### **DETAILED ACTION**

This office action is in response to the filing of the Applicant Amendment on 7/14/09. A note about the Examiner-Initiated Interview is included in the Response to Arguments below.

FIG. 2

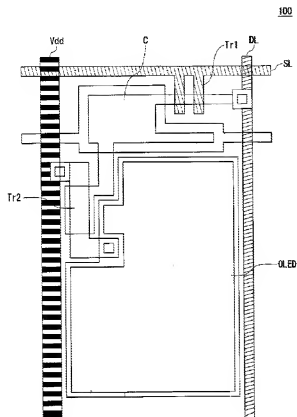
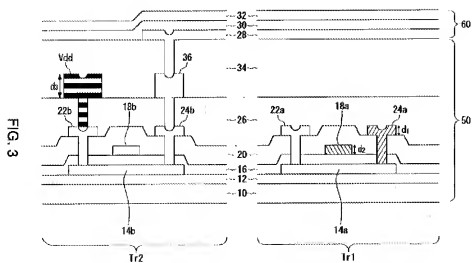
8. **In re claim 10**, Noguchi et al. teaches a flat panel display, comprising (Figures 2 and 3):

- an insulation substrate 10 divided into a plurality of pixel regions, each of said pixel regions being defined by a crossing of a gate line SL (or 18a) and a data line DL (or 24a), the insulation substrate 10 comprising a plurality of thin film transistors Tr1/Tr2, each thin film transistor being arranged in corresponding ones of said plurality of pixel regions;

- a first insulation film 16 arranged on the substrate 10 and on the plurality of thin film transistors Tr1/Tr2;
  - a gate electrode 18a, gate lines SL and data lines DL (or 24a) arranged on the first insulation film 16;

- a second insulation film 26 arranged on the gate electrode 18a, the gate lines SL and the data lines DL;
  - a plurality of pixel electrodes 28 arranged on the second insulation film 26 and being electrically connected to corresponding ones of said plurality of thin film transistors Tr2 in corresponding ones of said plurality of pixel regions;

- a power supply layer Vdd also arranged on the second insulation film 26, the power supply Vdd layer being electrically separated from the plurality of pixel electrodes 28, said power supply layer Vdd being electrically connected to each of the plurality of thin film transistors Tr2 and supplying power to each of the plurality of thin film transistors Tr2.

9. **In re claim 11**, Noguchi et al. shows that an entirety of the power supply layer Vdd is separated from an entirety of each of the gate lines SL (and 18a) and the data lines DL (also 24a) by the second insulation film 26 (Figure 3).

10. **In re claim 12**, Noguchi et al. shows that the power supply layer Vdd being formed in a line shape in which the power supply layer Vdd is arranged between corresponding ones of said plurality of pixel electrodes 28 of OLED, said power supply layer Vdd being arranged in one of a row or a column (Figure 2, also implied by Column 1, Line 8 – 9 and Column 2, Line 37 - 38).

11. **In re claim 13**, Noguchi et al. shows that the power supply layer Vdd having a surface electrode shape in which the power supply layer Vdd is formed on a whole surface of the substrate 10 and being electrically separated from each of the plurality of pixel electrodes 28 (Figure 3).
